ARDEN SENIOR LIVING CENTER

SITE DEVELOPMENT PLAN

PROJECT NUMBER: SPEC23422

DATE: JANUARY 03, 2023

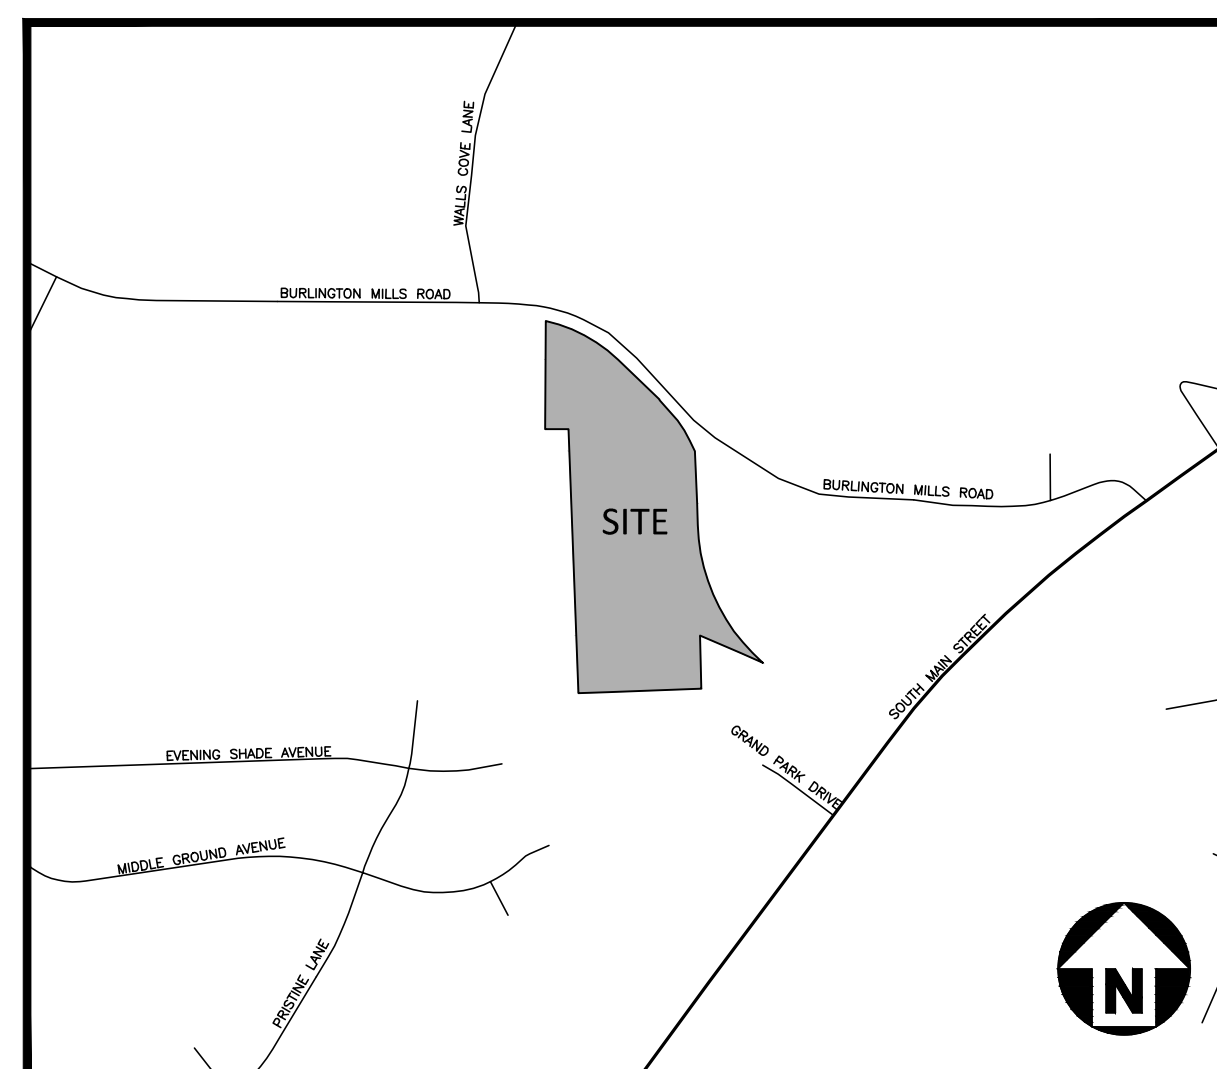
3.) site plan shows all VAN

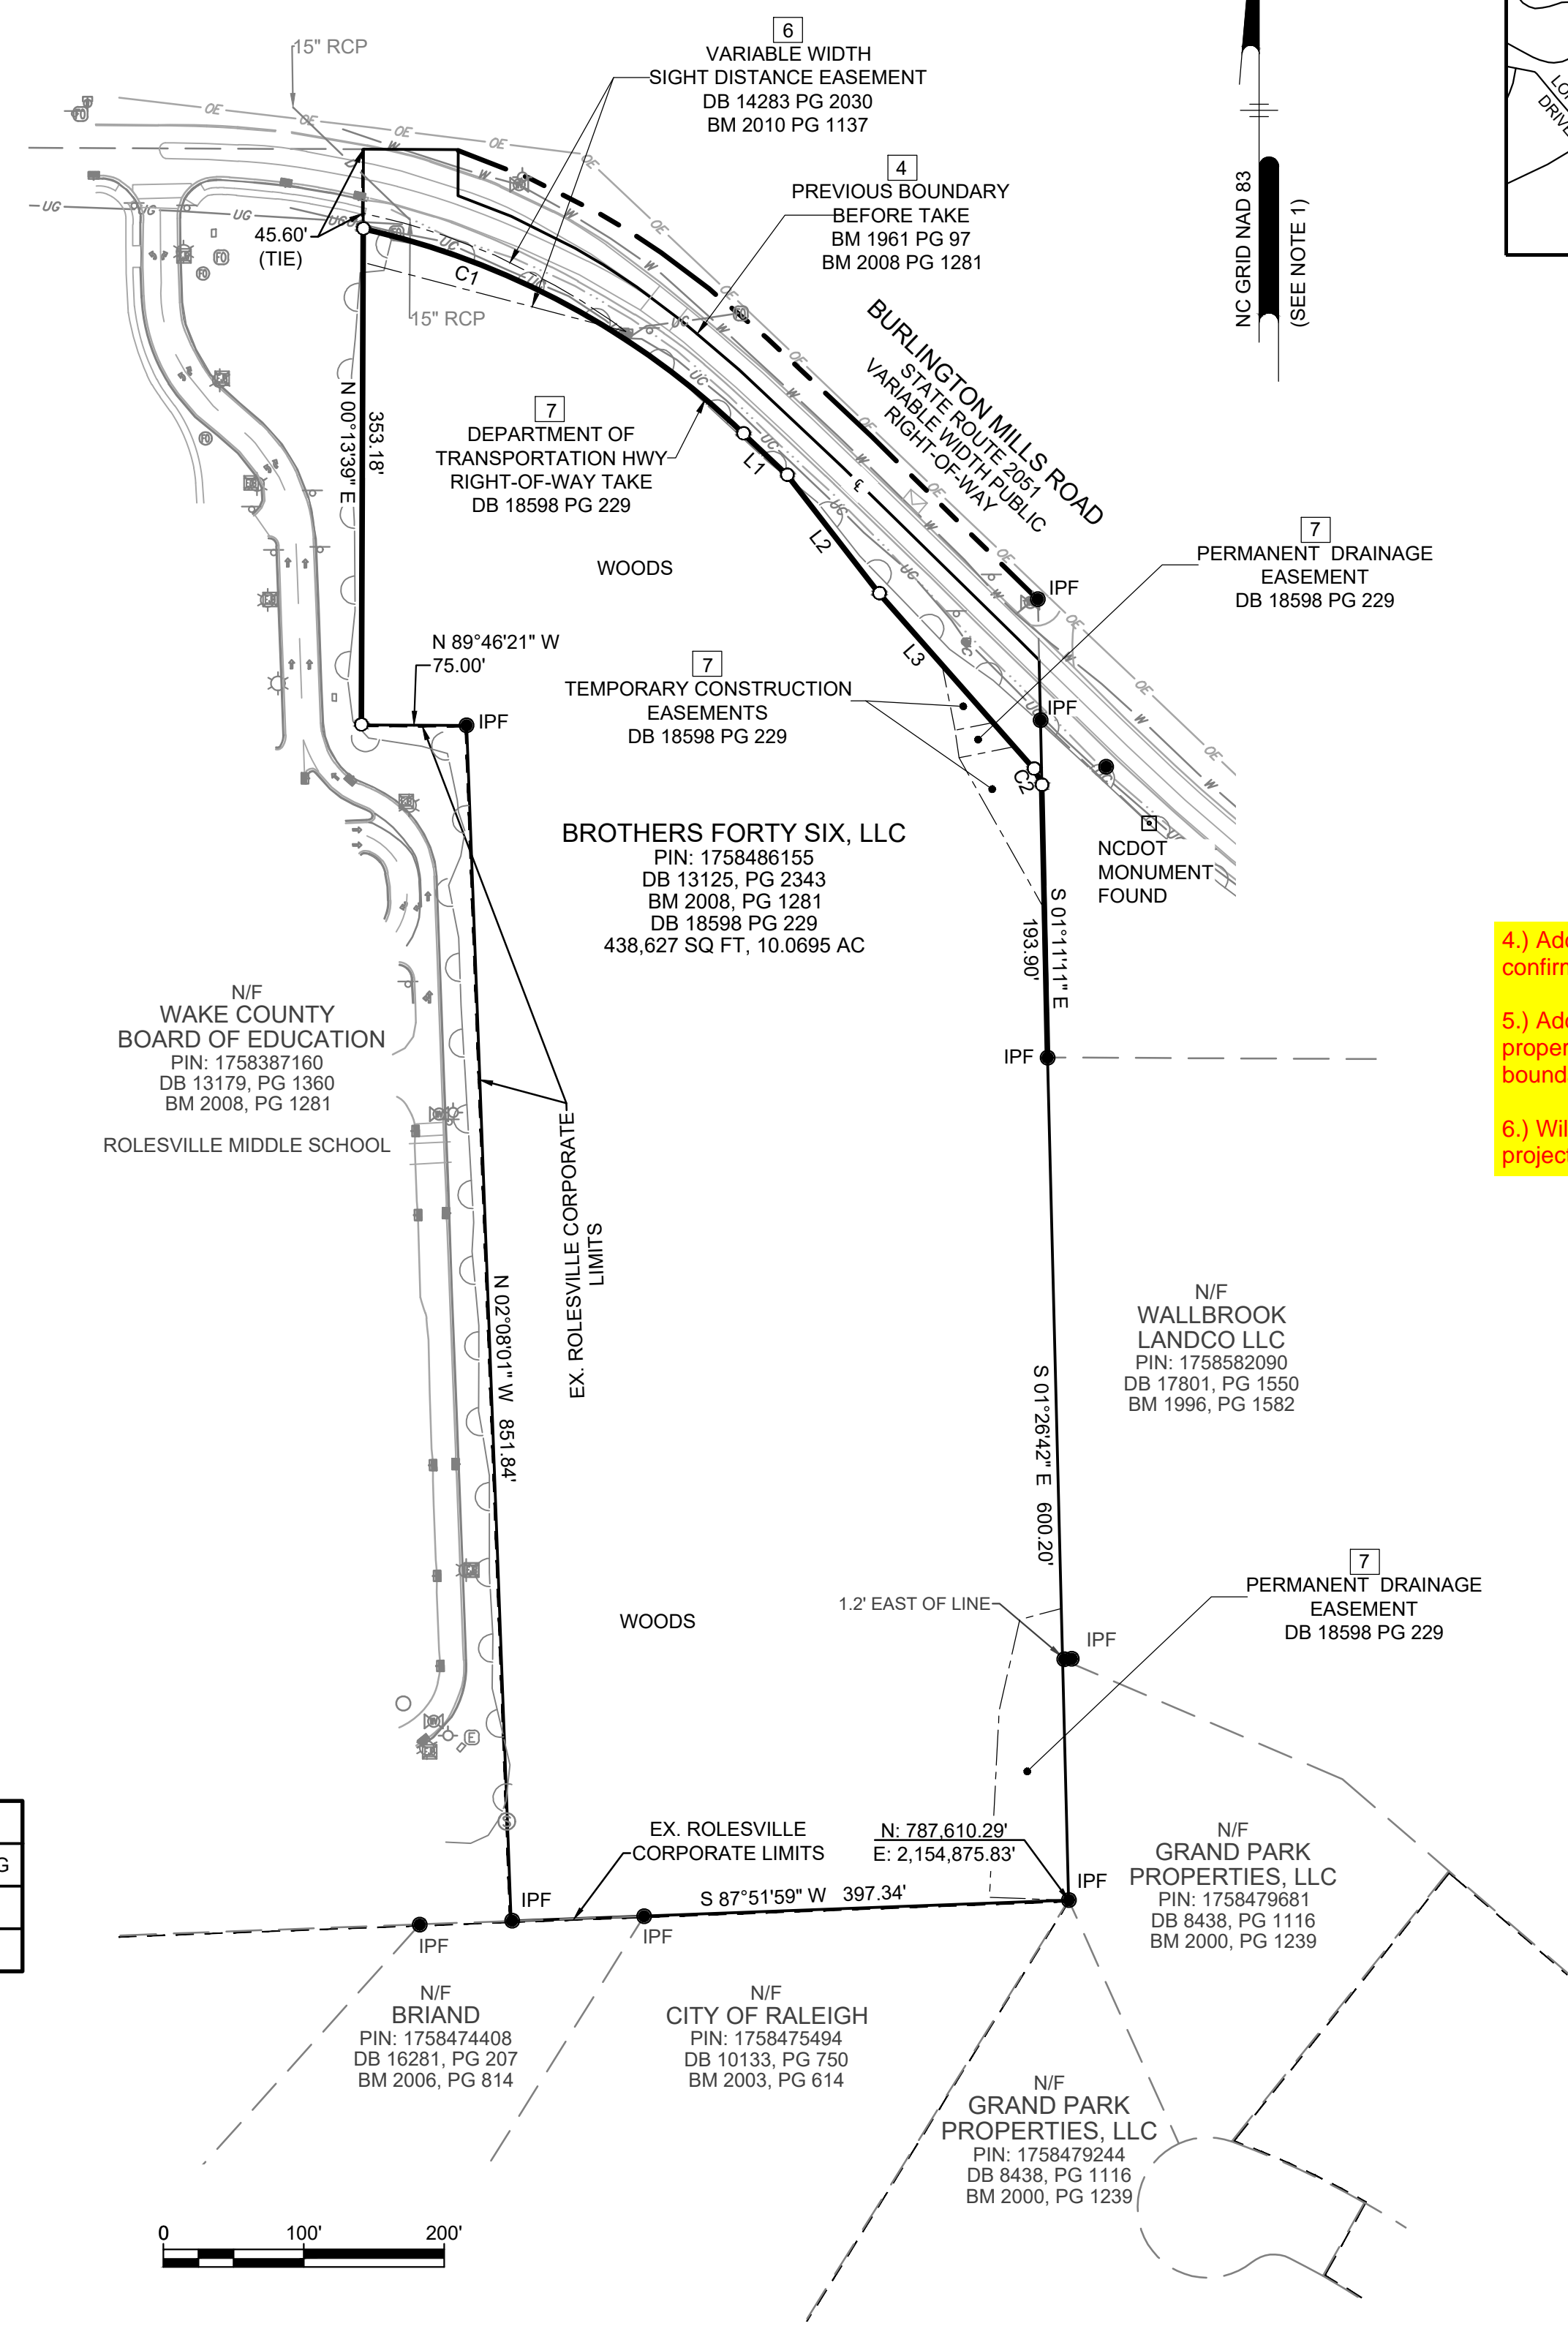
- Add zoning districts so we can confirm adjacent buffer requirements.
- Add Topographic contours for property and 100' past property boundaries.
- Will the (2) parcels be combined with project goes in for platting easements?

OVERALL GRADING AND STORM DRAINAGE PLAN

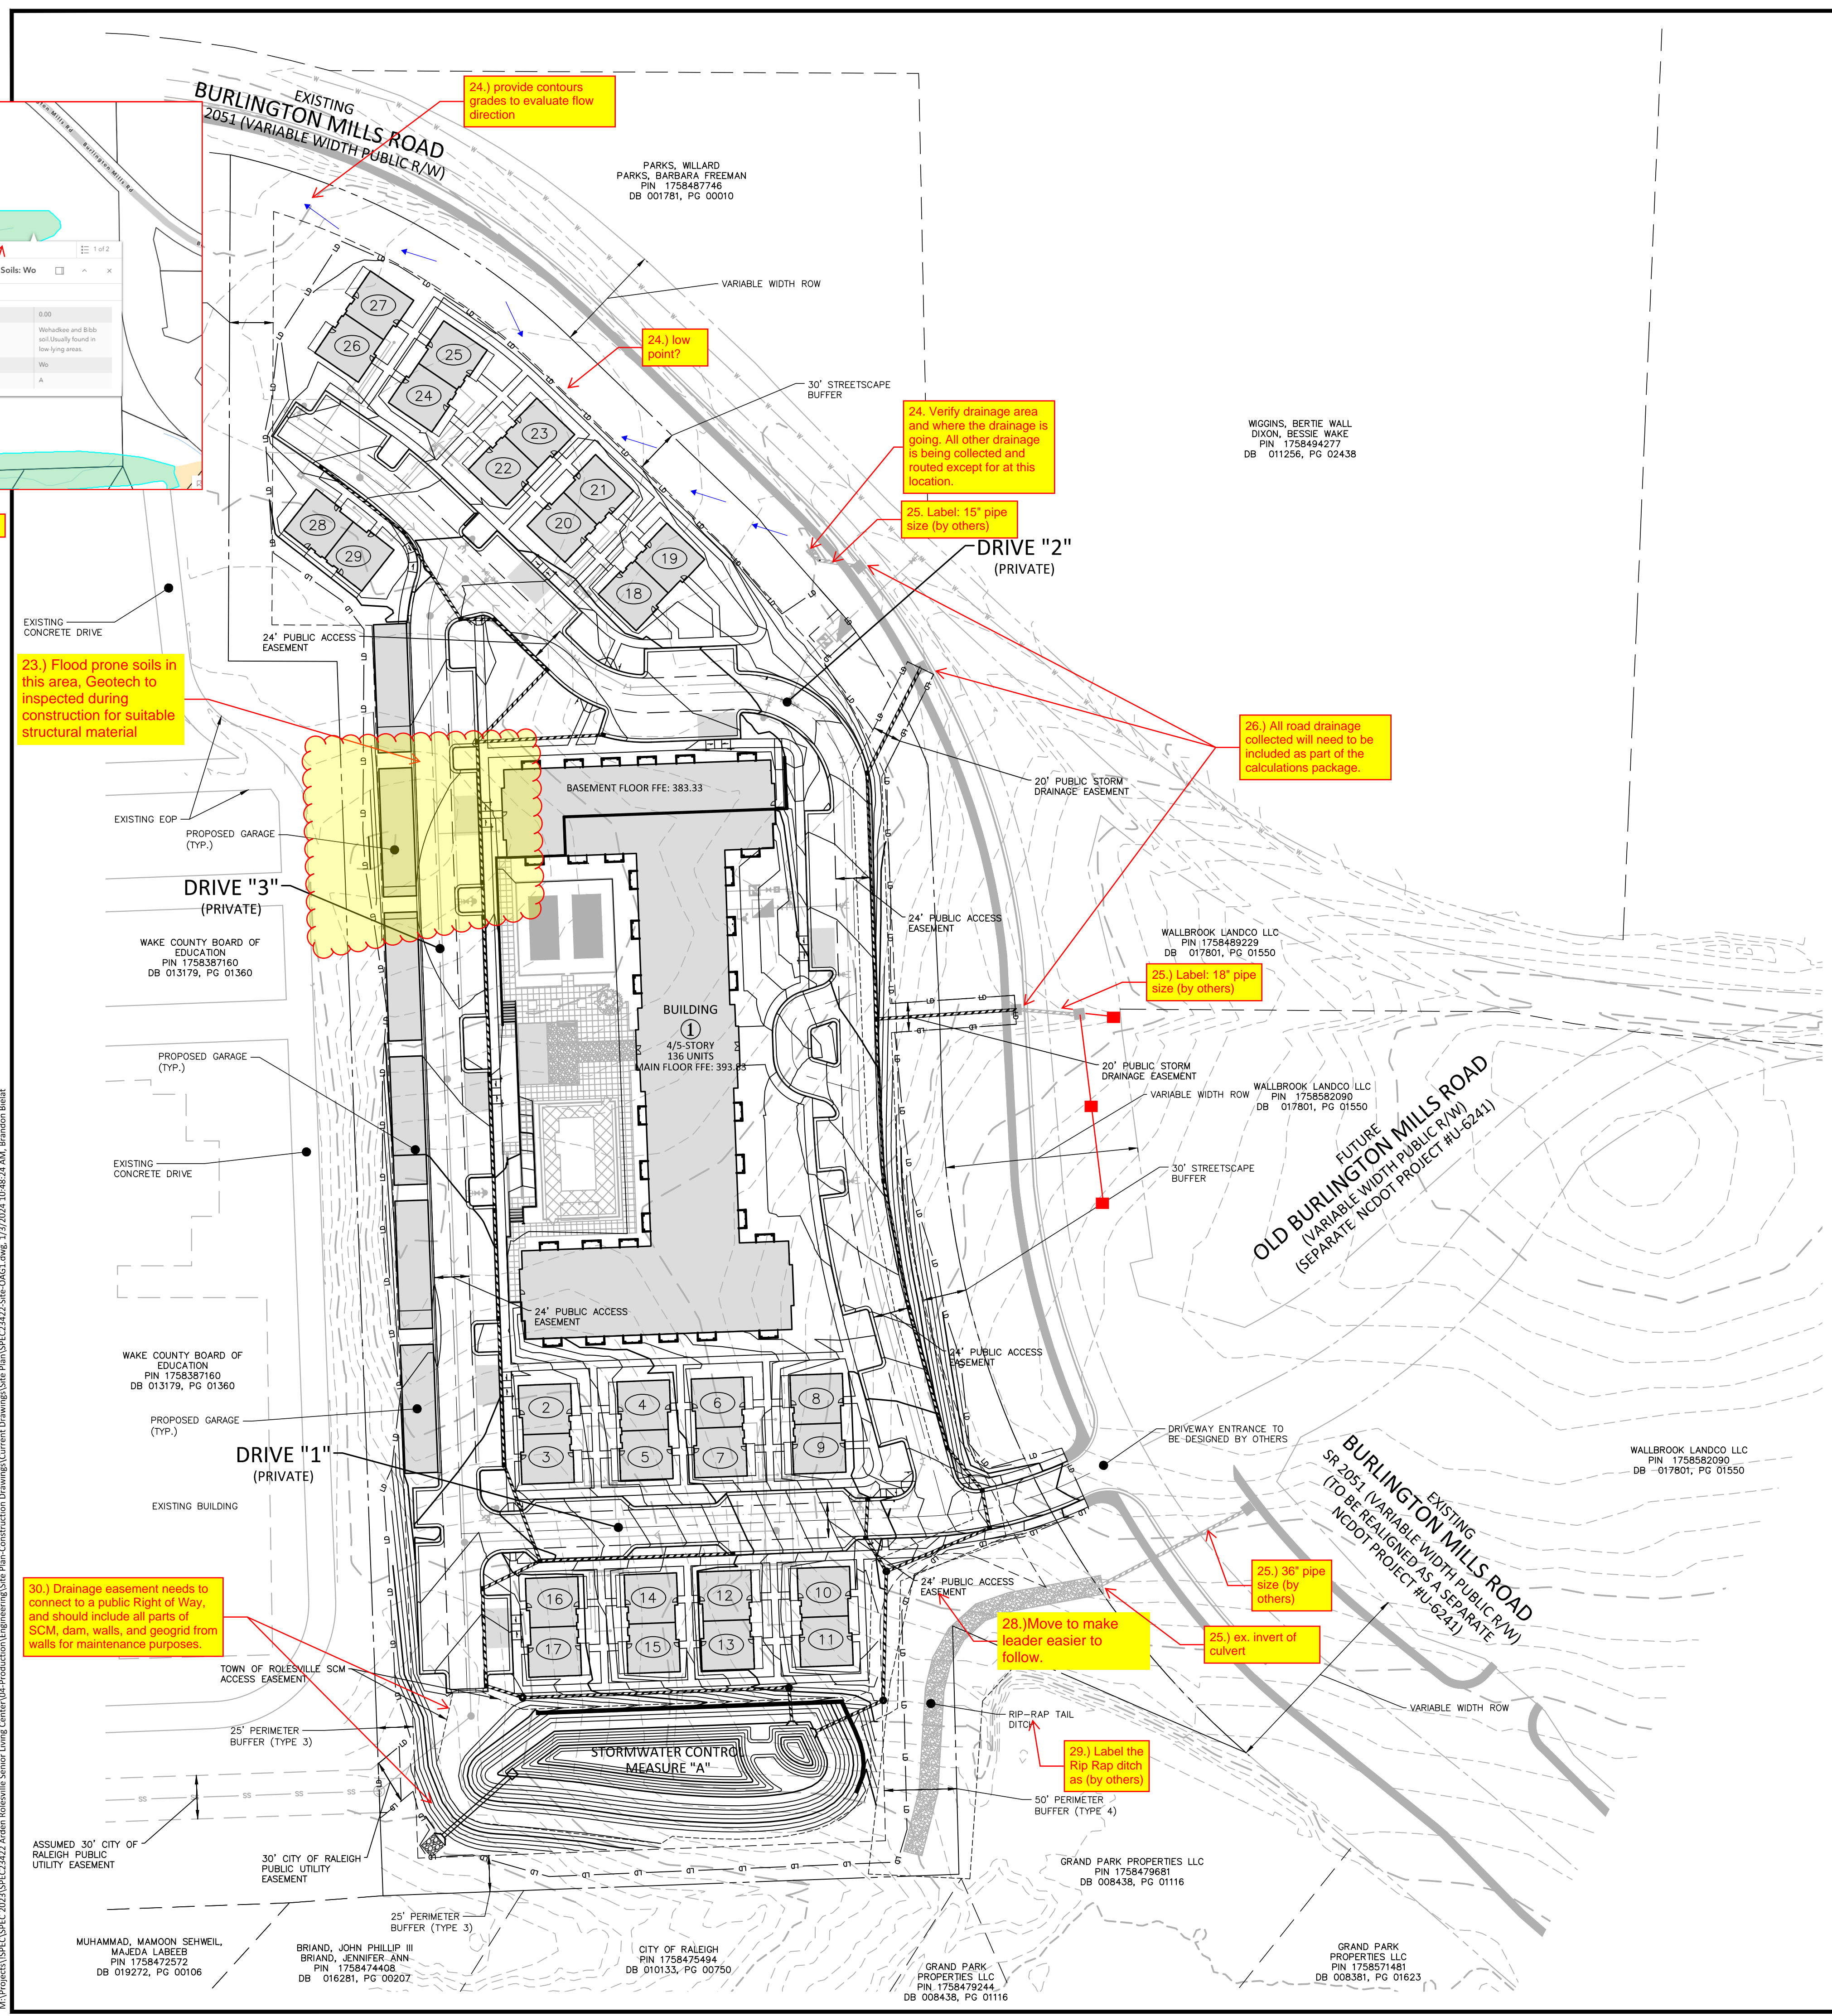
General Note: Not able to complete review with out information on storm drainage. Provide table/chart or provide labels in sheet with design info.

24.) provide contours grades to evaluate flow direction

24. Verify drainage area and where the drainage is going. All other drainage is being collected and routed except for at this location.
